**ADDENDUM NO. 7**

October 16, 2024

**CORNER CANYON HS FIELD HOUSE**

12943 South 700 East  
DRAPER UT, 84020

## SYNTHETIC TURF EDGE DETAIL - 6" x 12" CURB

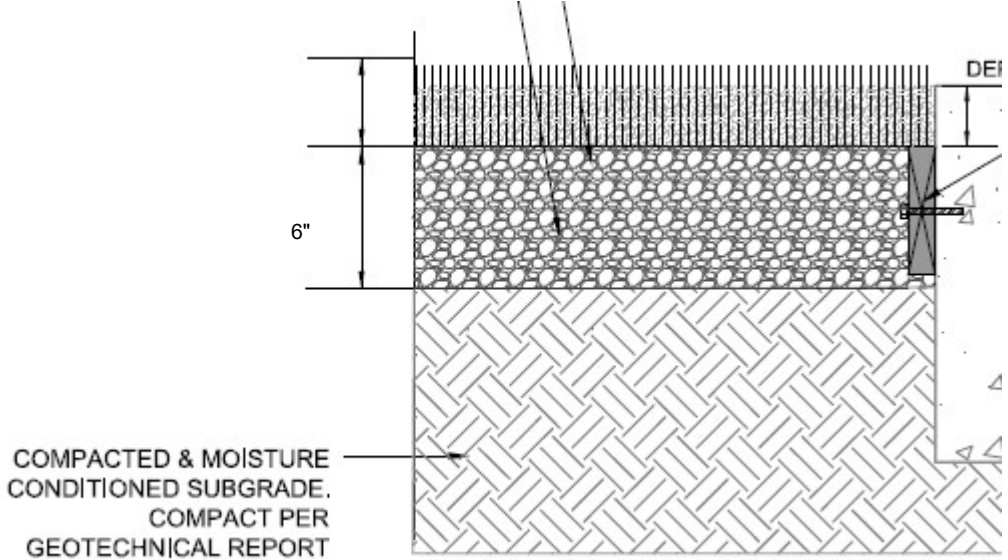
1. Owner Provided Turf - See the attached details provided by field turf for depths of owner provided turf:

**Outdoor FT Profile:** This is our standard profile for the outdoor field. As you can see, the holddown on the field for the GC from top of curb is 7-3/8" (or 7.5"). Holding the nailer down 1.5" from the top of curb is acceptable and how we typically build it.. The field has a crown in it (marked as ridge on the grading plan), so please make sure the subgrade mimics this crown, keeping the hold down of 7.5". I inserted a couple comments that you can remove or change (i.e. there is a thickened edge and not a curb; showing where subgrade is; the red box is by GC).

SHEET TITLE  
**ENLARGED TURF FIELD**  
 SHEET NUMBER  
**A817**

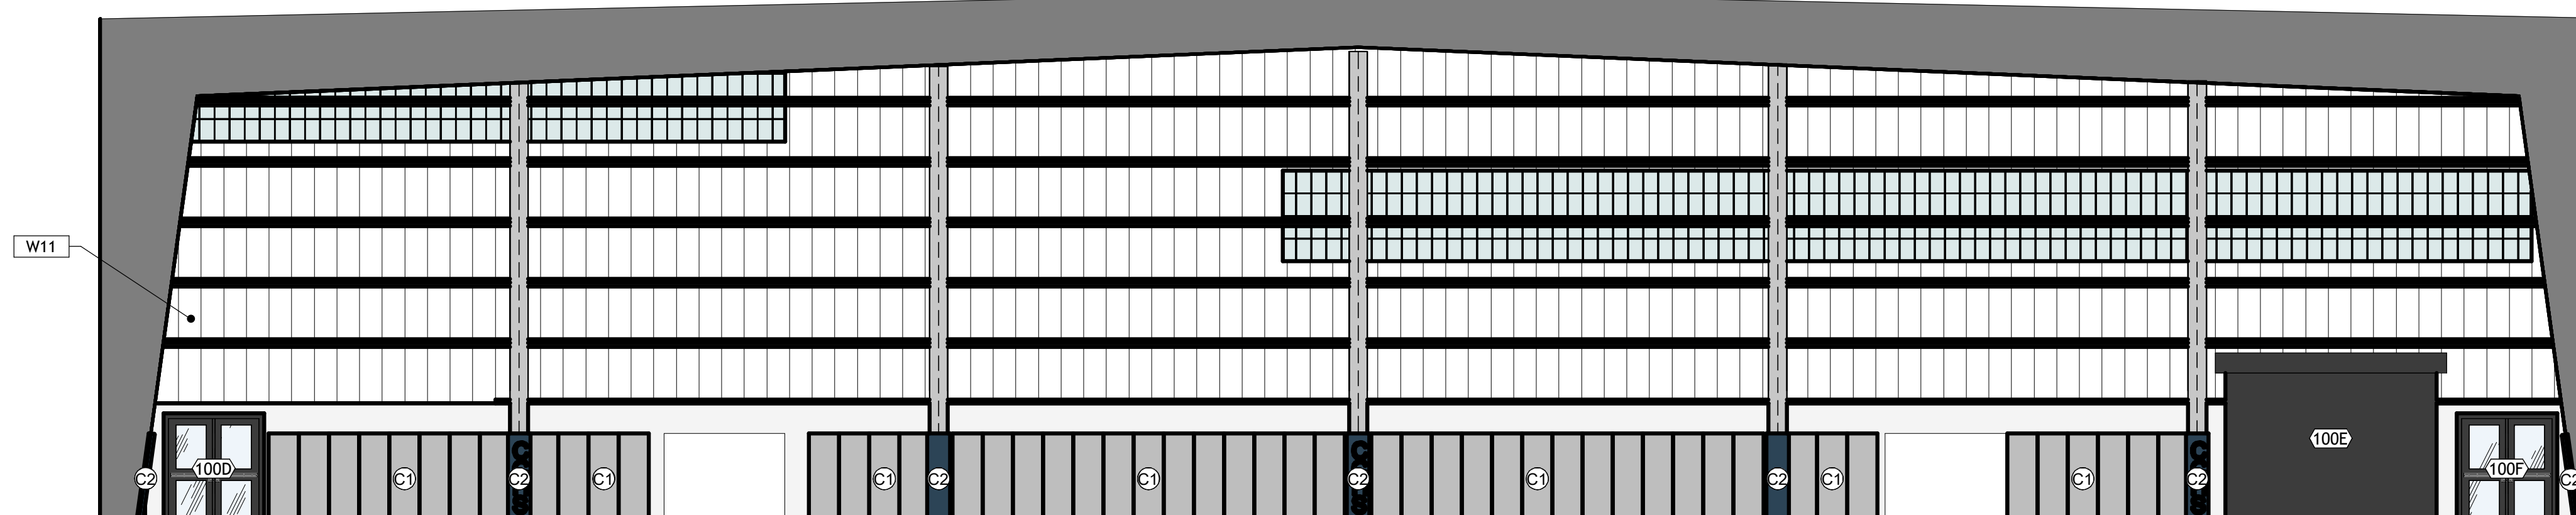
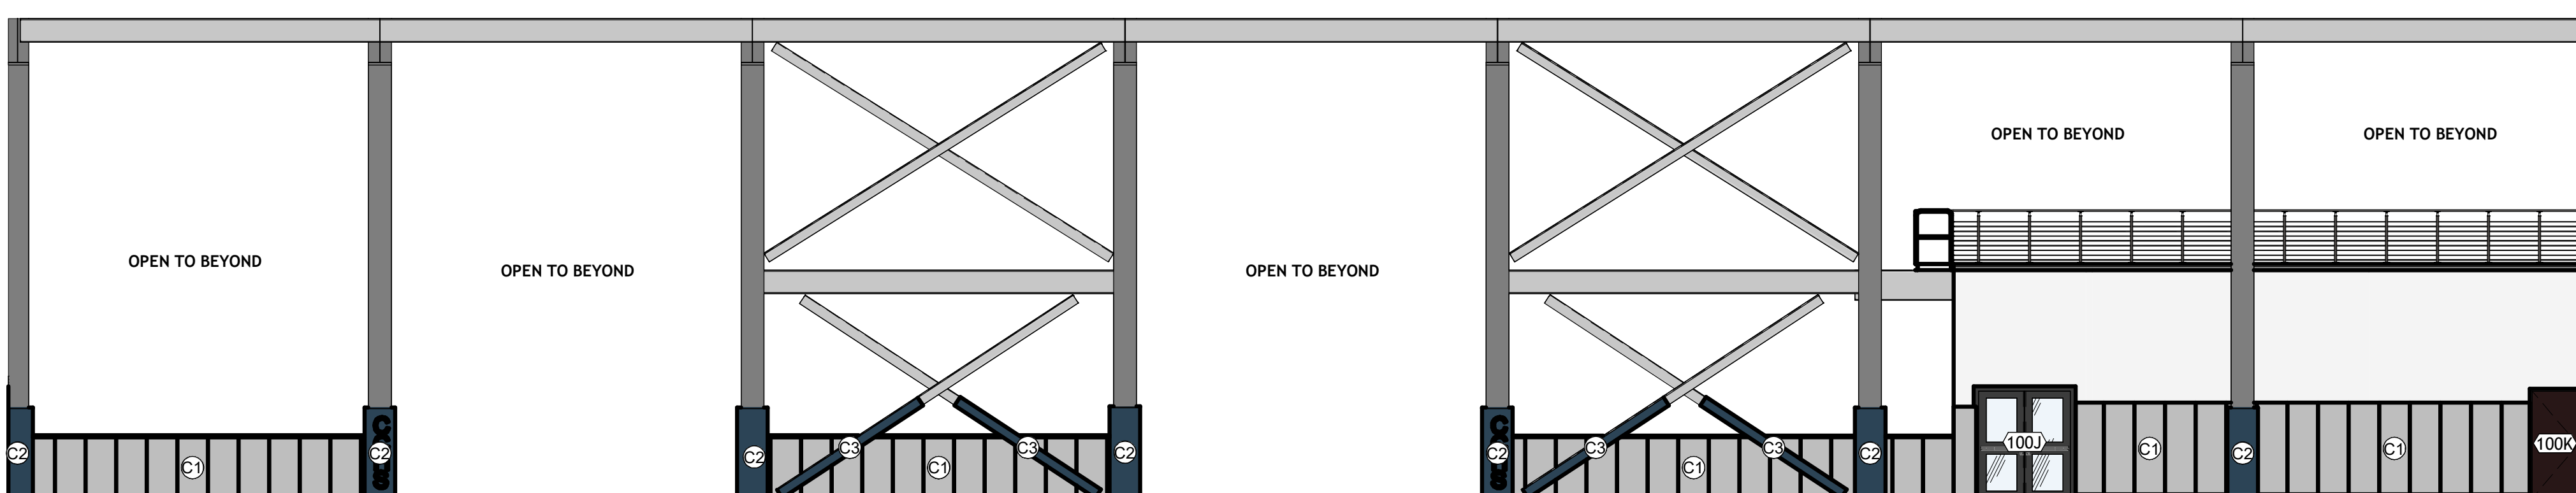
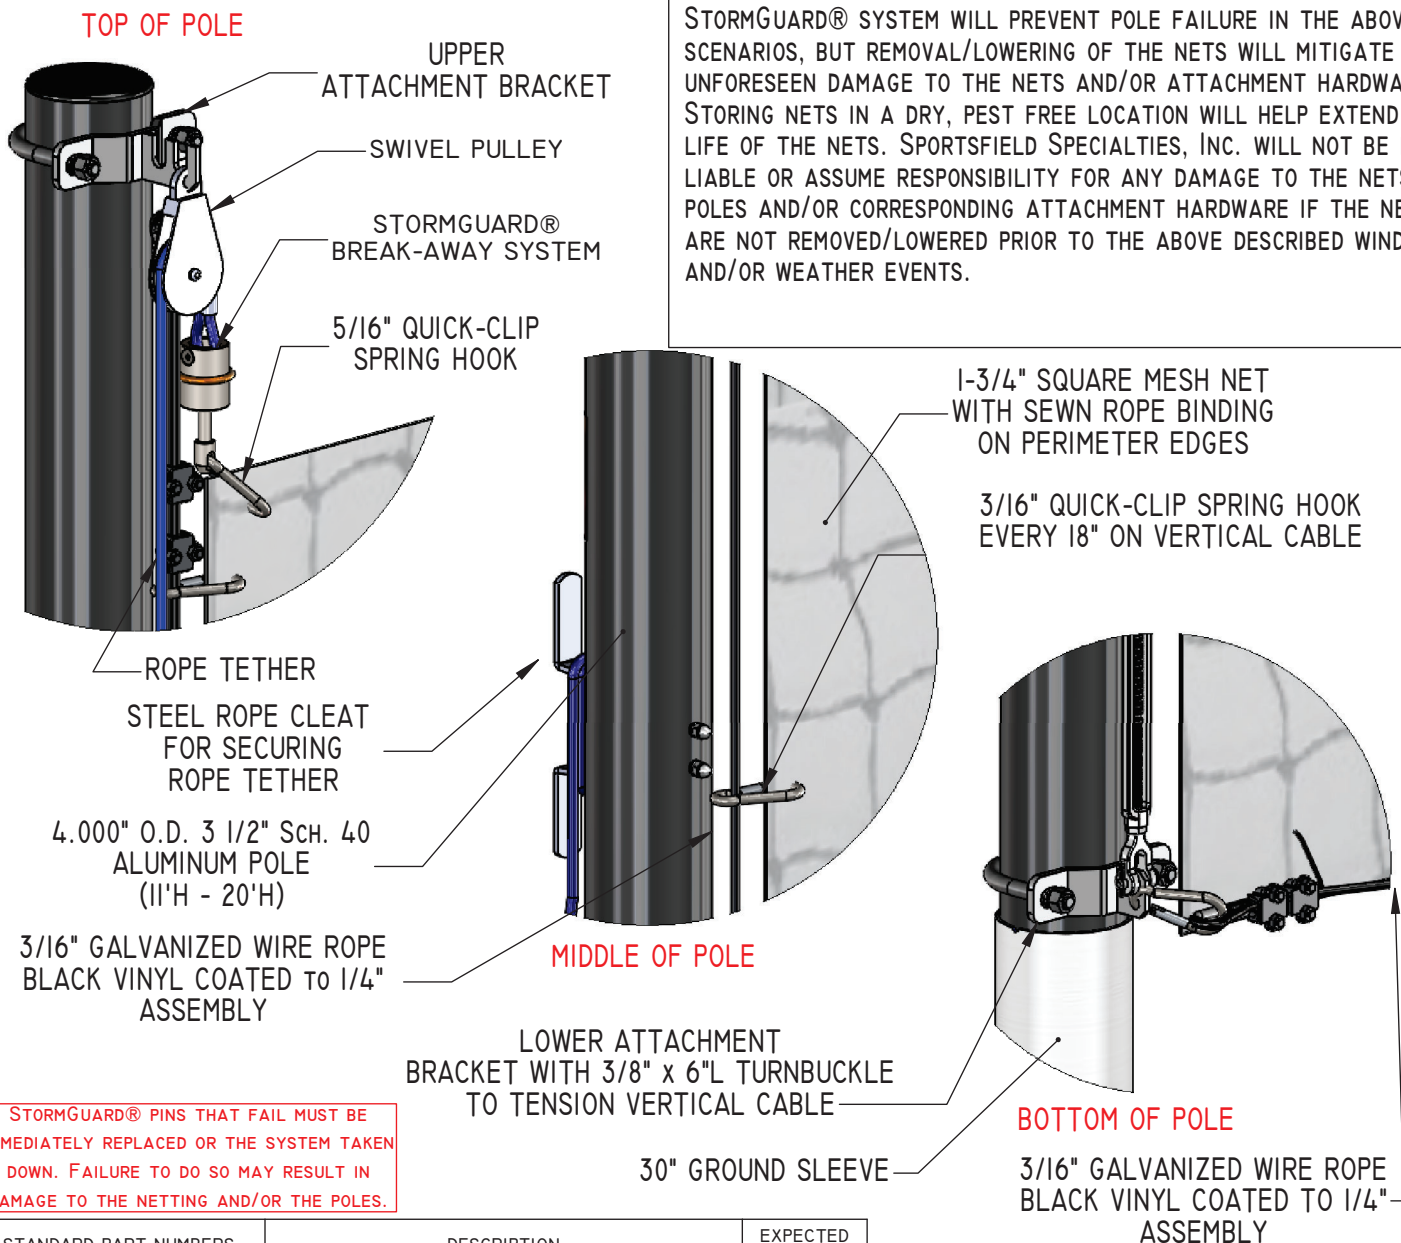
REVISIONS		
NO.	DESCRIPTION	DATE
3	ADDENDUM #4	10/09/2024
5	ADDENDUM #7	10/15/2024

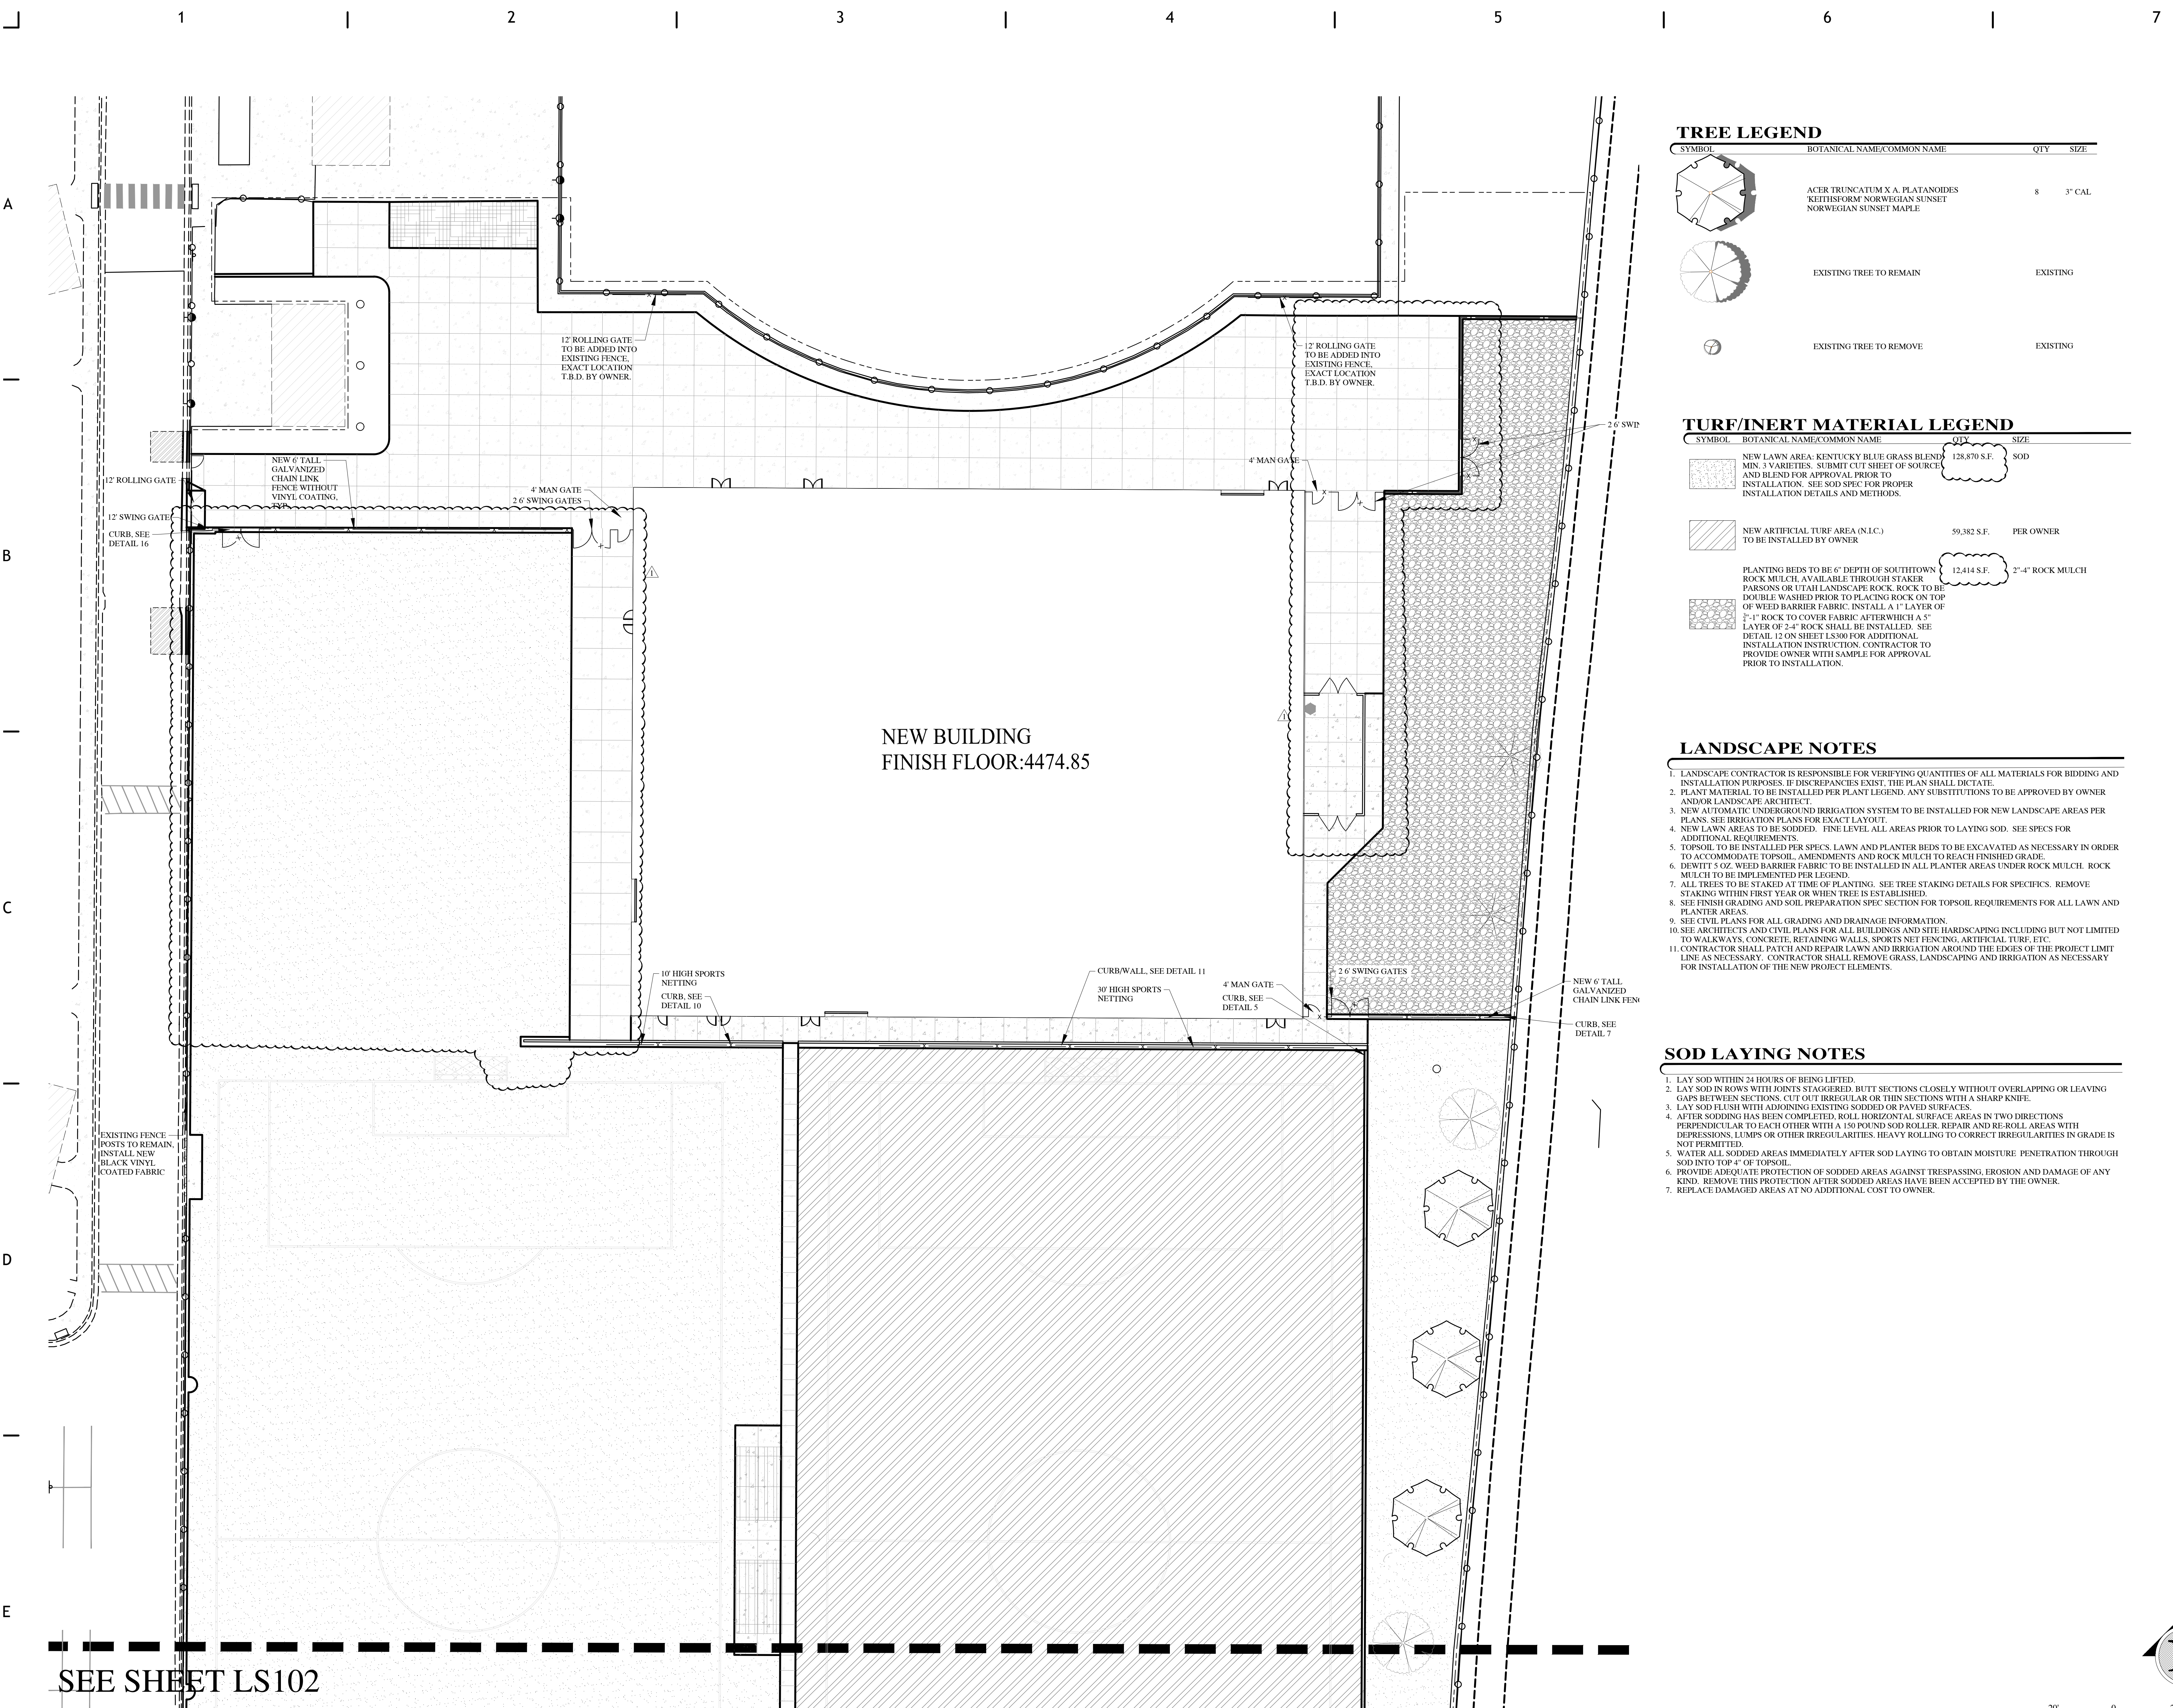
The fire marshal has requested the added fire truck access on the east and west sides of the fieldhouse. Changes are as follows:

1. The concrete sidewalk on the west was widened and the lawn area reduced.
2. The concrete sidewalk and plaza on the east side was widened and rock mulch area was reduced.
3. A double swing gate was added to the east and west side of the fieldhouse.
4. Irrigation zones 2 and 3 were adjusted and re-piped.
